# Independent Peer Review Panel

## IPRP Report No. 8, December 17, 2014

### **Comments on PG&E's Central Coastal California Seismic Imaging Project Report part 2: onshore seismic studies intended to reduce the uncertainty in seismic hazard at Diablo Canyon Power Plant**

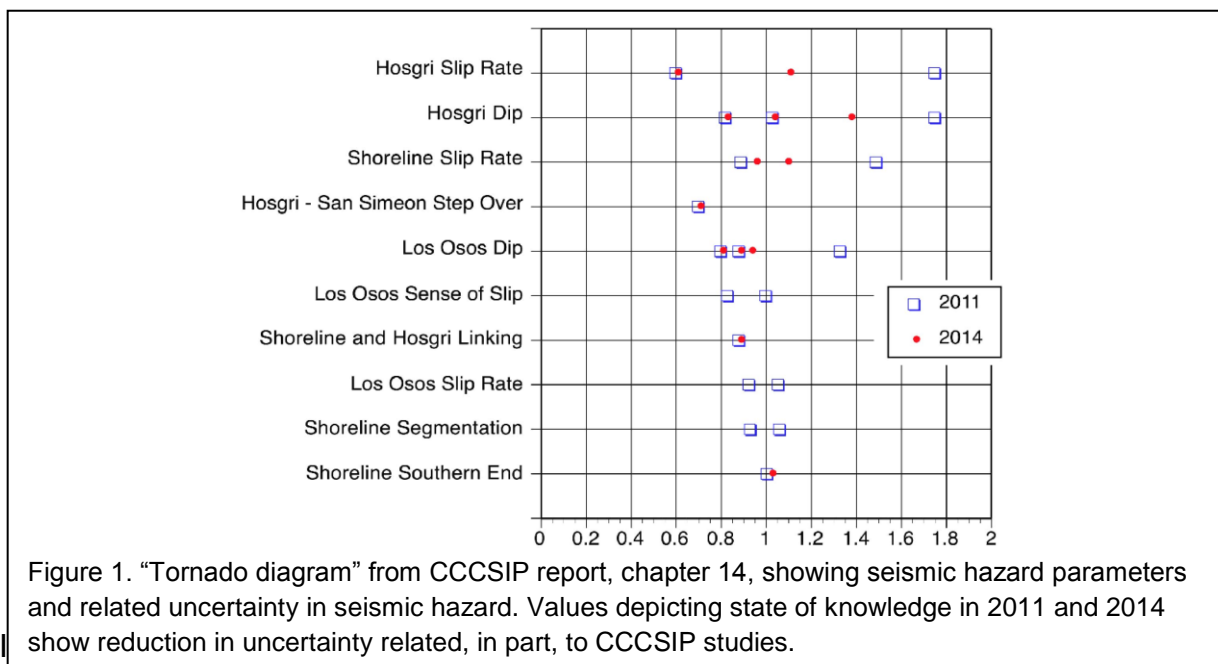
At the IPRP meeting on November 17, 2014, PG&E project manager Stuart Nishenko presented an update of the “tornado diagram” from the August 11, 2011 memo report. In the updated “tornado diagram” (Figure 1), the distance between points related to a hazard parameter represents the uncertainty in seismic hazard resulting from that parameter. In this type of diagram, parameters that are poorly constrained and have a

large effect on hazard are shown as widely separated points at the top of the diagram. Closely spaced points shown near the base of the diagram can be either parameters that are well-constrained or parameters that are poorly-constrained but have slight effect on hazard.

As stated by Dr. Nishenko, reducing the uncertainty in the parameters near the top of the “tornado” will have the greatest effect in reducing the uncertainty in hazard. The depiction of uncertainty in 2011 and 2014, particularly the lower uncertainty for the parameters at the top of the “tornado” show PG&E’s estimate of how much uncertainty in seismic hazard has decreased due to studies described in the CCCSIP report. The parameter with the greatest impact on seismic hazard, slip rate on the Hosgri fault, was the main subject of IPRP Report No. 7.

This report includes discussion of seismic hazard parameters including dip and sense of slip on the Los Osos fault (fourth and fifth from the top of the “tornado”). The IPRP notes that the parameters shown on the “tornado diagram” are the parameters included in the 2011 seismic hazard analysis. As stated in IPRP Reports No. 2 and 3, an important emphasis of on-land seismic surveys should be to determine if there are additional faults that should be considered and an overall “tectonic model” describing the location, sense of slip, and level of activity on faults within the Irish Hills.

As in IPRP Report No. 7, the IPRP notes that the parameters shown on the “tornado diagram” are all “seismic source characterization” parameters. Other parameters, especially “site conditions” or “site amplification” parameters can have equal or greater impact on seismic hazard calculations as any shown on Figure 1. Site conditions and seismic amplification factors were the subject of IPRP Report No. 6 and are discussed in other sections of the CCCSIP report. These factors will be addressed in a subsequent IPRP report.
